**Interdisciplinary Science Building
Webster University
Cannon Design Project No. 004561.01**

Project: Webster ISB Substitution Request Number: _____
From: _____
To: Melissa Pirtle stl-
cac@cannondesign.com Date: _____
Re: _____ Contract For: _____

Specification Title: Fibre-cement siding Description: Swiss Pearl
Section: 074646 Page: 2 Article/Paragraph: 2-2-products

Proposed Substitution: 8mm Equitone Standard (natura) (dark base) panel
Trade Name: Equitone Panel Systems
Model No.: Universe 7000 panel system
Manufacturer: Universe Cladding solutions
Address: 3333 Foerster Rd, Bridgeton, MO 63044

UNIVERSE® 7000 Cascadia Clip Thermal Spacer Insulation System
(Exposed Fastener with EQUITONE using Mineral Wool Insulation)

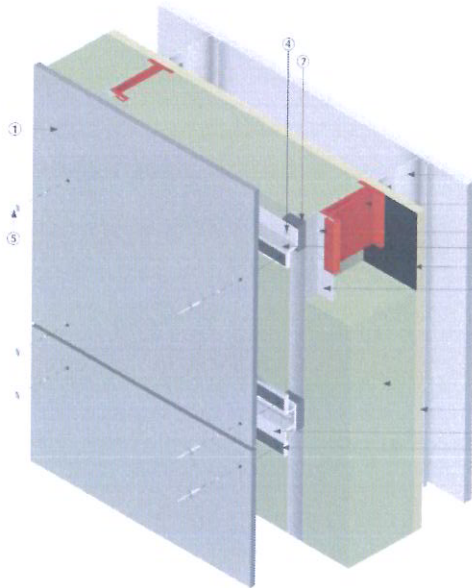
Comments: The provided color samples are not acceptable. Please provide a color sample that matches the color specified. The intent is to match the color of metal panel & curtain wall mullions.

☒ **Provide color sample that match the color per specifications.**
